# Product update information

PUI12-03 KSC

The current tape for series KSC2 and KSC3 tape, for gull wing terminals (G) has been improved in order to avoid perforation of the tape by terminal during violent shocks on the reel.

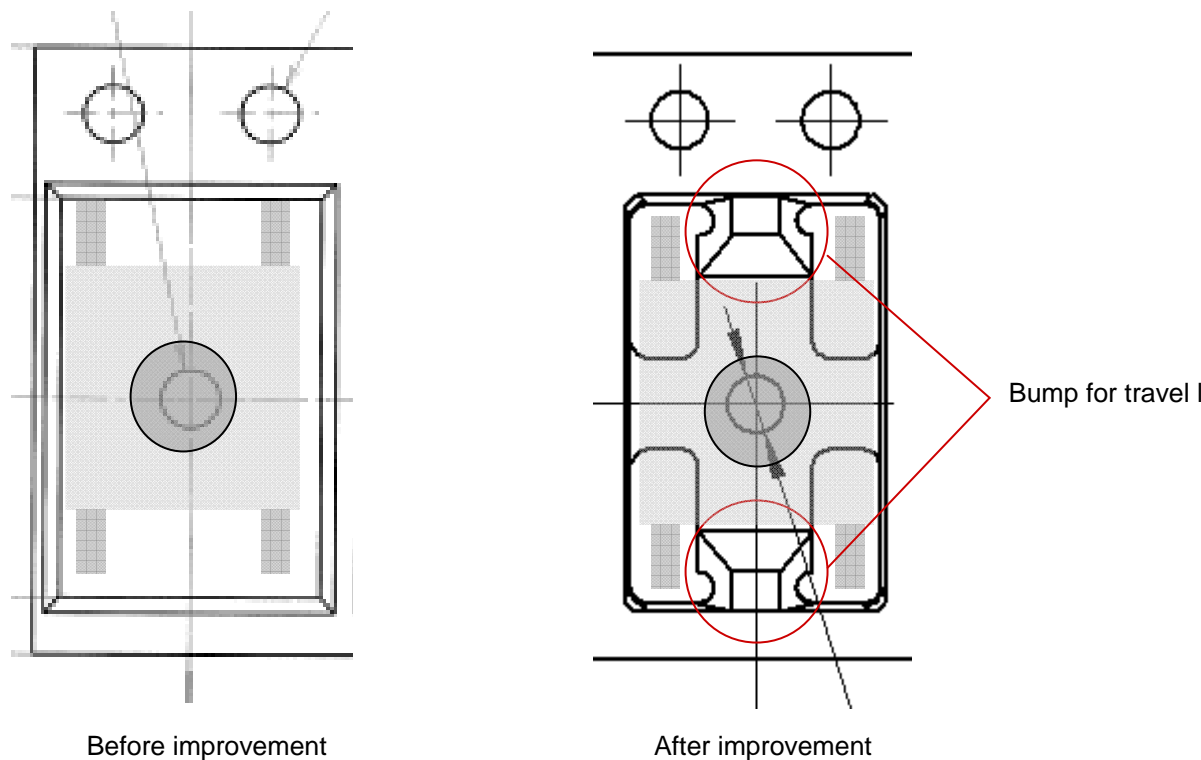
The improved tape cavity design allow a guidance on the switches sides, made by bumps, and avoid contact of terminals on the cavity walls by the limitation of the possible translation of the switch during shocks. Drawing below describes the improvement.

Overall dimensions of the tape such as hole diameter, pitch, width remain unchanged.
